**FRONT SUSPENSION POPPING NOISE WHILE TURNING RIGHT OR LEFT—VEHICLES BUILT BEFORE 4/8/2005**

**TSB 05-9-11**

**FORD:**  
2005 Mustang

Figure 1 - Article 05-9-11

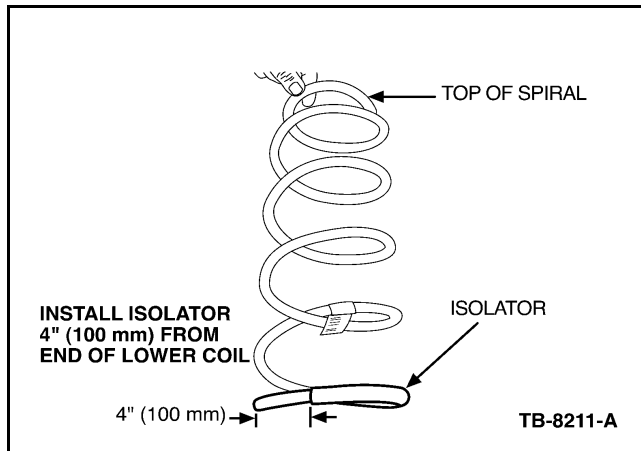
1. Remove the strut and spring assembly. Refer to Workshop Manual Section 204-01.
2. Disassemble the strut and spring assembly.
3. If the springs do not have a rubber isolator on the bottom spring coil, install isolators. Clean off any dirt prior to installing the isolator. The isolator should be installed 4" (100 mm) from the end of the coil (Figure 1).
